SERVICE BULLETIN

Reference number:	SB-01-1168	Issued: 11 December, 2018
Subject:	Boot-Lid Trim Clips	
Model(s):	Vanquish Zagato Volante and Vanquish Zagato Speedster	
VIN Range:	All Vanquish Zagato Volante vehicles to chassis no. K34421 All Vanquish Zagato Speedster vehicles to chassis no. K54470	
Applicable to:	All Dealers	
Distribute to:	After Sales Manager Executive Manager Service Manager Sales Manager	Warranty Staff Technician(s) Parts Staff

Figure 1

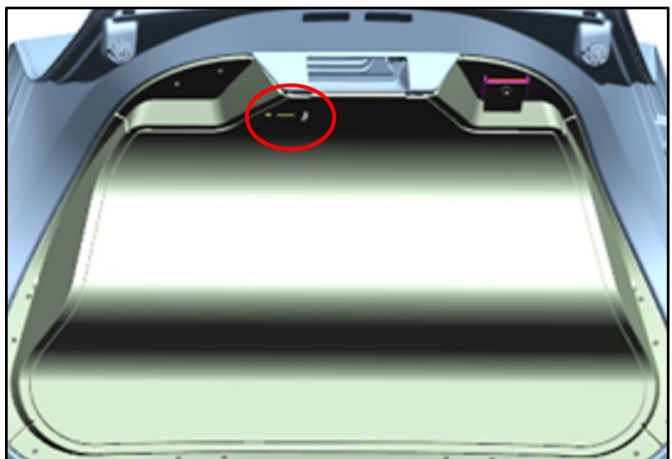
1. Open the boot lid.
2. Remove the emergency release handle for the boot lid (refer to Figure 1).

There is a problem with the clips for the boot lid trim on Vanquish Zagato Volante and Vanquish Zagato Speedster vehicles. In some conditions the clips are not sufficiently strong to hold the boot lid trim in the boot lid. New boot-lid trim clips are available to replace the clips initially installed in the vehicles.

Figure 3

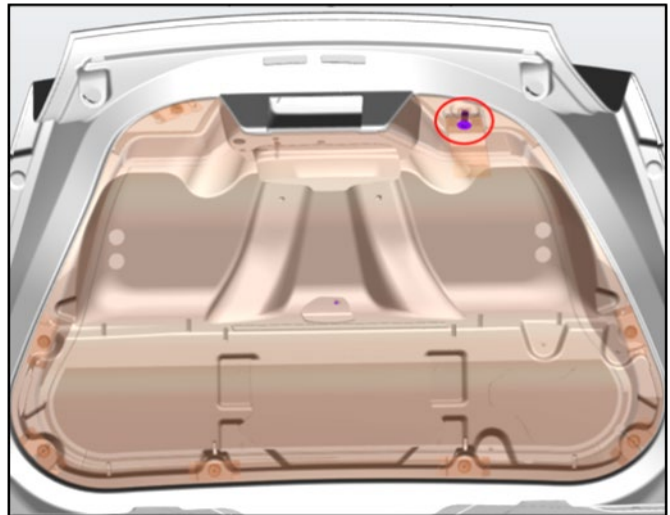
3. Remove the screw that attaches the boot lid trim and pull-down-strap to the boot lid (refer to Figure 2 and Figure 3).

Figure 4

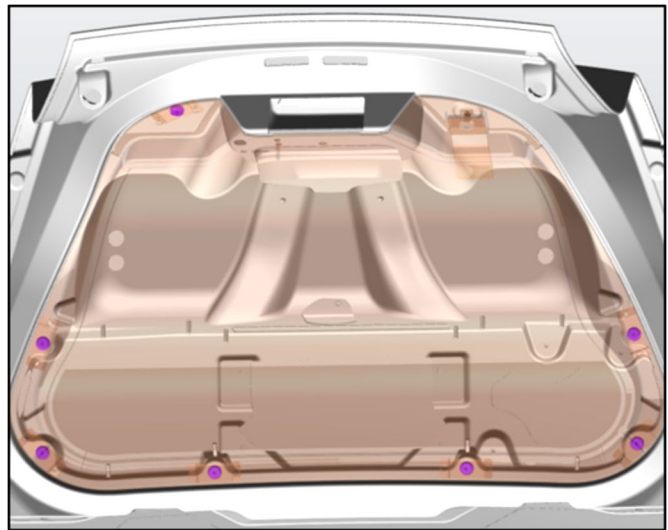
4. Use a trim removal tool to release the boot lid trim from the boot lid (refer to Figure 4).

5. Remove the boot lid trim from the boot lid.
6. Replace the seven boot-lid trim clips with seven fir tree clips.
7. Move the boot lid trim into position in the boot lid.
8. Install the boot lid trim in the boot lid. Make sure the clips go in the center of the holes. Replace the clips if they become damaged.
9. Install the screw that attaches the boot lid trim and the pull-down-strap to the boot lid (refer to Figure 2 and Figure 3).
10. Tighten the screw to 8Nm.
11. Install the emergency release handle for the boot lid (refer to Figure 1).
12. Close the boot.
